## **Accessibility Design Review Report**

Brewery Yard Redevelopment

Central Park, Chippendale NSW 2008

**Phase:** DA Submission

The areas/spaces highlighted in **pink** below have been identified as areas that would be considered exempt under this part.

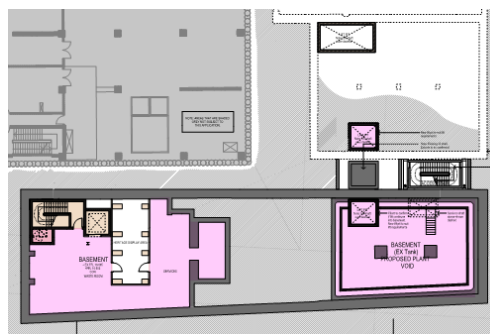
Based on the use of some areas within a building, it is reasonable to not provide access to some spaces where it is deemed inappropriate because of the required duties to be carried out in the space or if the area poses as a health or safety risk for people with a disability. These areas include:

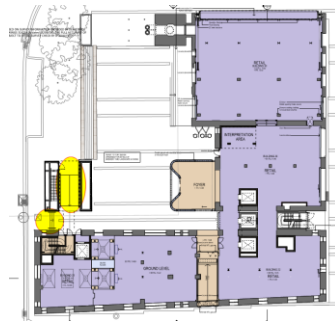
Warning Tactile Ground Surface Indicators (TGSIs) and/or provision of bollards shall be provided either side of the car park entry points on Grace Avenue and Forest Way to adequately identify the roadway hazard for pedestrians using the footpath. In addition, TGSIs will be provided at kerb ramps and at pedestrian crossings in accordance with AS1428.4.1 and Council requirements.

- Stair / ramped access is indicated at the western boundary

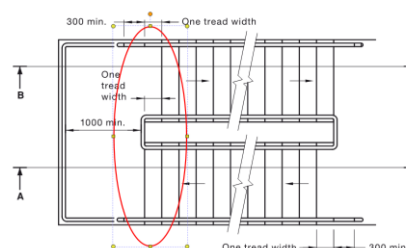
All existing public circulations stairs and ramps (excluding fire-isolated stairs/ramps) must be upgraded to be provided with handrails/kerb rails to both sides, handrail extensions & turndowns, nosing strips (Stairs) and Tactile Ground Surface Indicators (TGSIs).

Circulation stairs and ramps will be required to be set-back from transverse paths of travel so that handrail extensions do not protrude into corridor paths of travel.

Offsetting the stair at the mid landing will allow a continuous single handrail which will not require vertical sections.

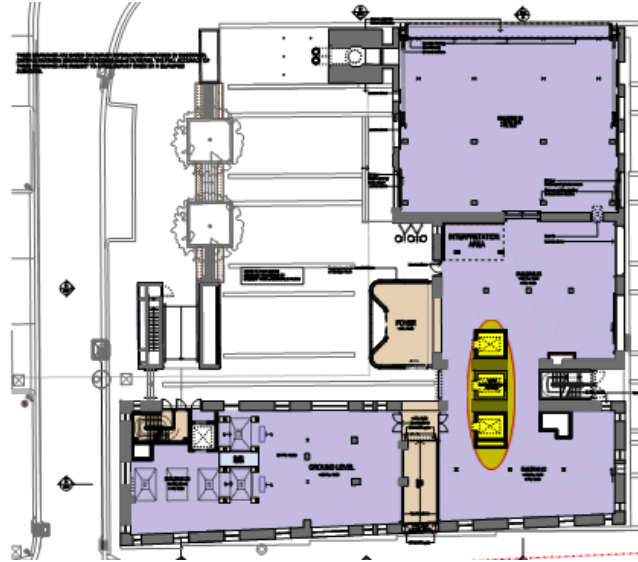
Multiple exiting passenger lifts are provided and located centrally within the development.

Any lift travelling greater than 12m requires a minimum compartment size of 1400mm wide x 2000mm depth (requires 2000mm depth where stretcher use indicated and travelling >12m).

Any lift travelling less than 12m requires a minimum compartment size of 1100mm wide x 1400mm depth.

Amenities are proposed in the following locations highlighted in yellow:

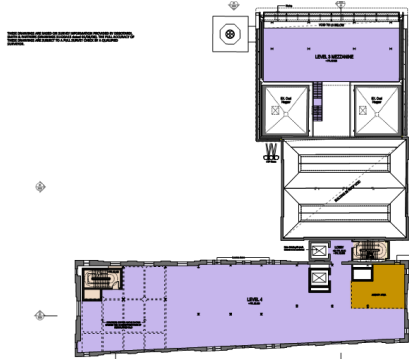
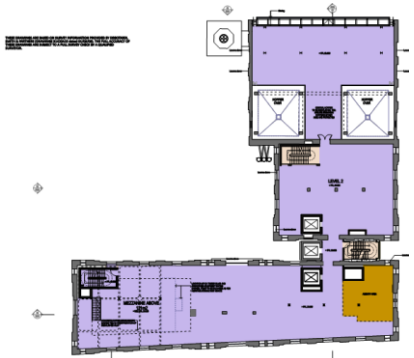
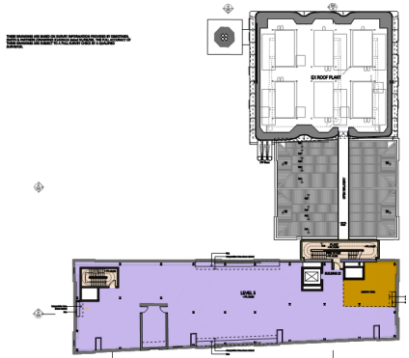
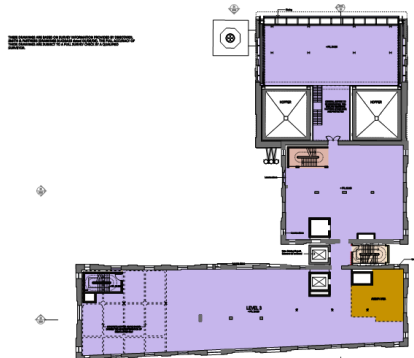
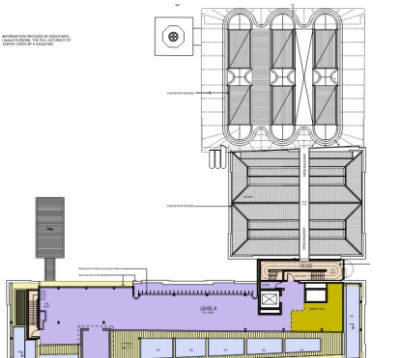
The development is for the construction of a cold shell fitout. Provision of amenities is limited to the supply of services only. Fitout of amenities shall be carried out by others.
